DEVELOPMENT REVIEW BOARD MEETING

Black Rock Coffee 21-DR-2018

Request: Request approval of a new restaurant with 340 square feet of outdoor dining patio, a drive-through service window, and 1,887 square feet of building area on a 0.6-acre pad site within a 1.65-acre site.

**Stipulations for the
Development Review Board Application:
Black Rock Coffee
Case Number: 21-DR-2018**

SITE PLAN
A11

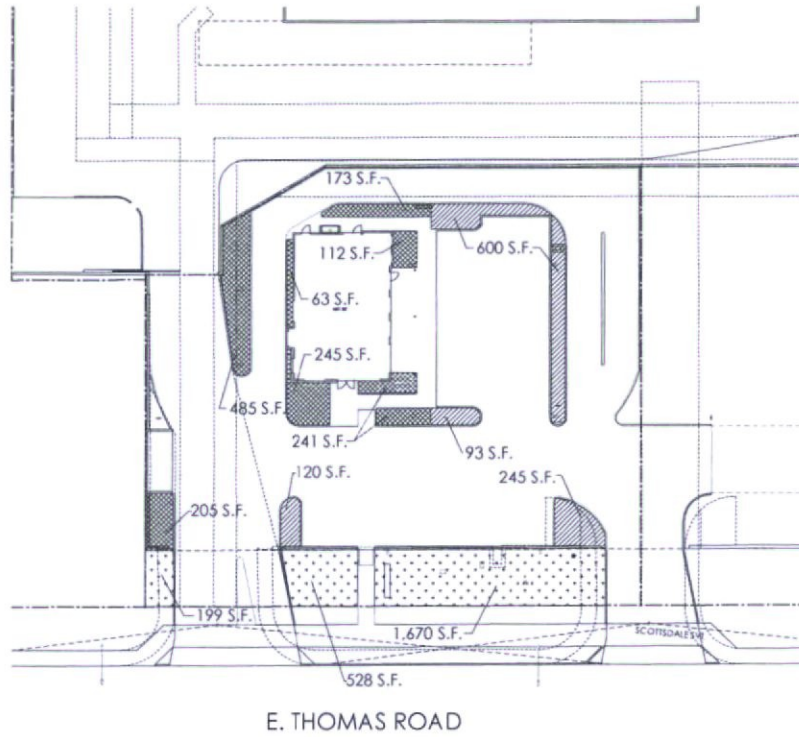
9. With the Final Plans submittal, the drive-through curbing design shall be modified to provide a radiused curb with landscape in place of the square corner at the northeast corner of the drive-through lane.
10. All drive aisles that are fire lanes shall have a minimum width of twenty-four (24) feet.
11. Before any building permit is issued for the site, the owner shall submit plans and receive approval to construct all refuse enclosures in conformance with the City of Scottsdale Supplements to MAG Standard Details 2147-1 for double enclosures.
12. With the final striping plan, the on-site drive aisles along the west side of the parcel and the drive-through exit aisle shall be configured to indicate which vehicle has the right-of-way.

LANDSCAPE PLAN
0' 10' 20' 40'
SCALE: 1"=20'-00"

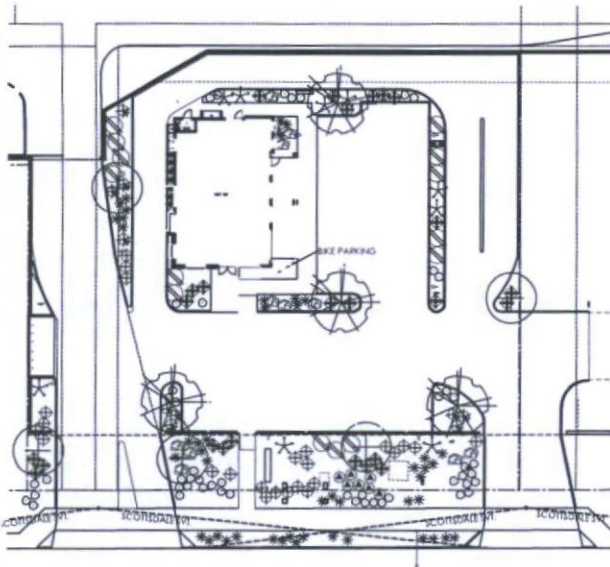
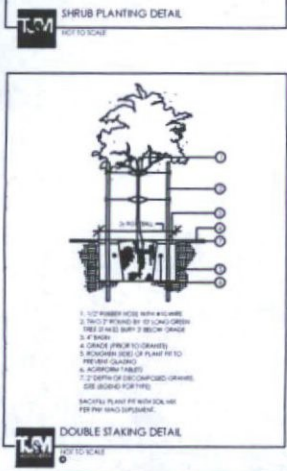
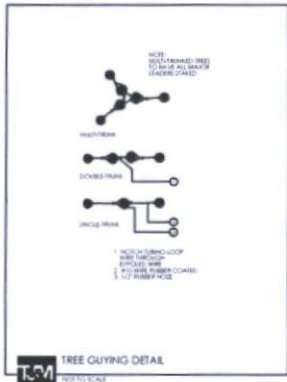
24. **With the Final Plans submitted, the landscape plans shall be revised to include two (2) additional trees in the landscape area west of the drive-through exit lane to provide additional shading and screening to the pick-up window and west building elevation.**

EXTERIOR ELEVATIONS	
ISSUED BY	DRP
DATE	05-25-18
SCALE	AS SHOWN

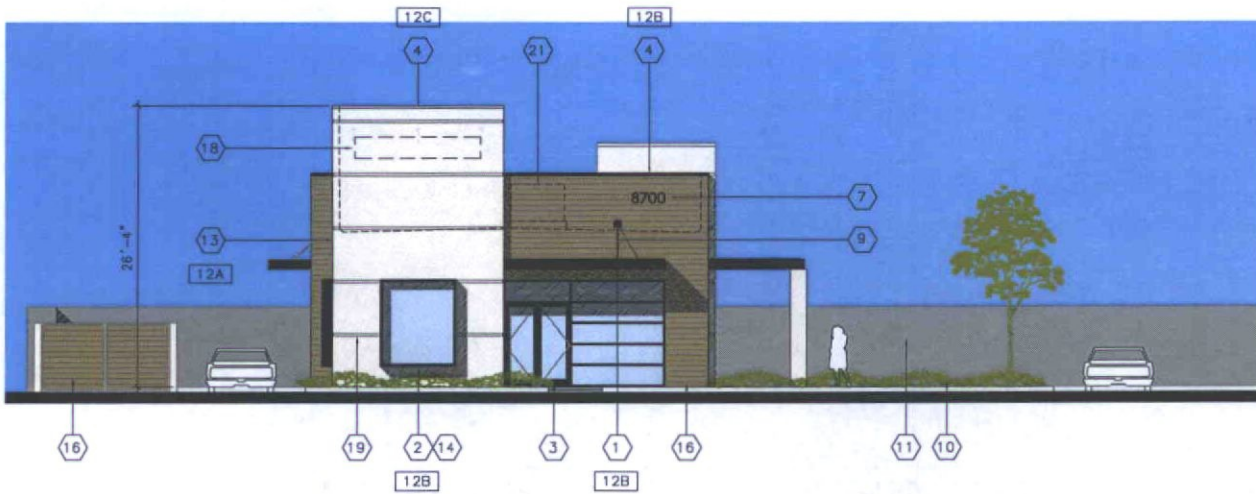
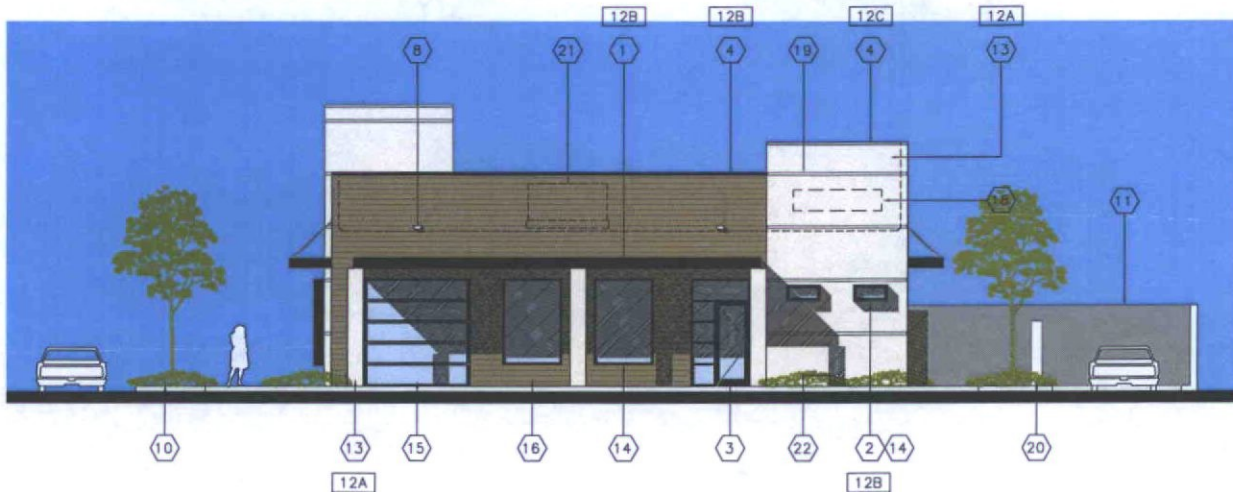
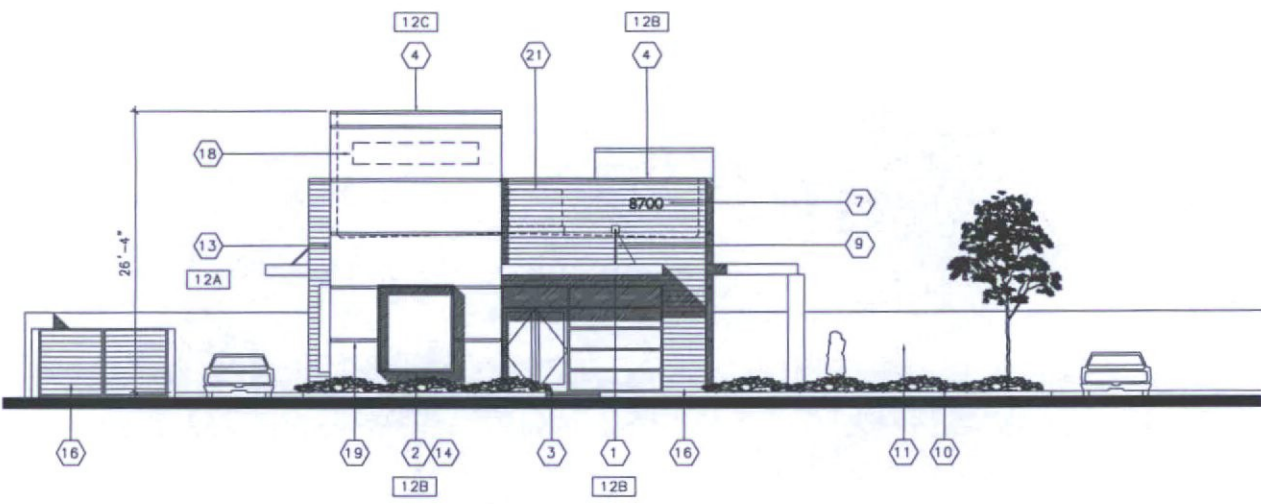
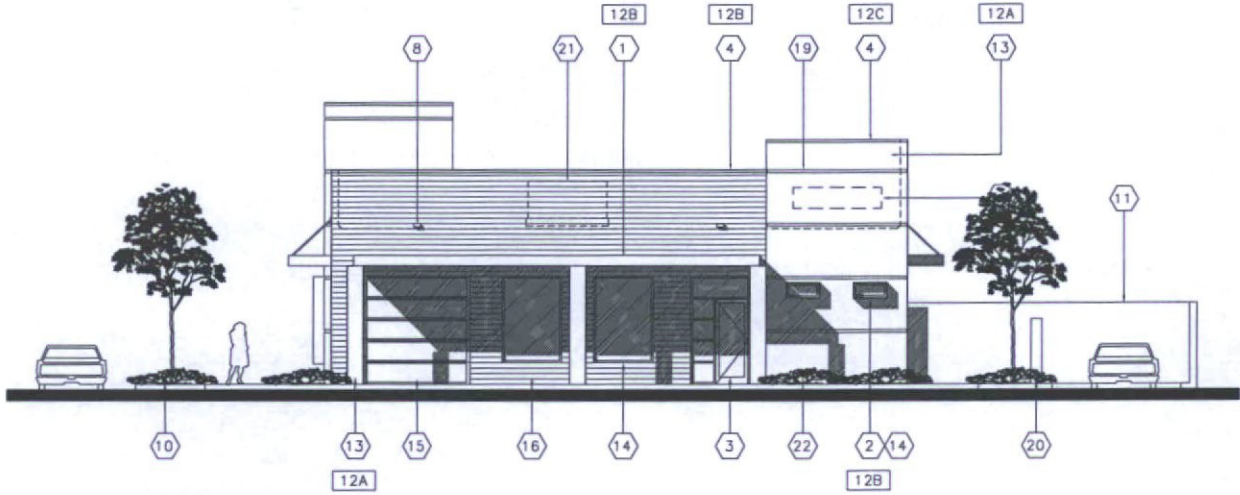
7. With the Final Plans submittal, the building elevations and site plan shall be revised to provide a porte-cochere over the drive-through window and lane instead of the cable-suspended flat canopy. In accordance with the Scottsdale Restaurant Design Guidelines, drive-through elements should be architecturally integrated into the building, rather than appearing to be applied or 'stuck on' to the building. The porte-cochere shall mirror the design of the patio cover found on the east building elevation.

8. With the Final Plans submitted, the design of the columns for the patio and the porte-cochere shall be revised to include horizontal reveals similar to the reveals on the building.
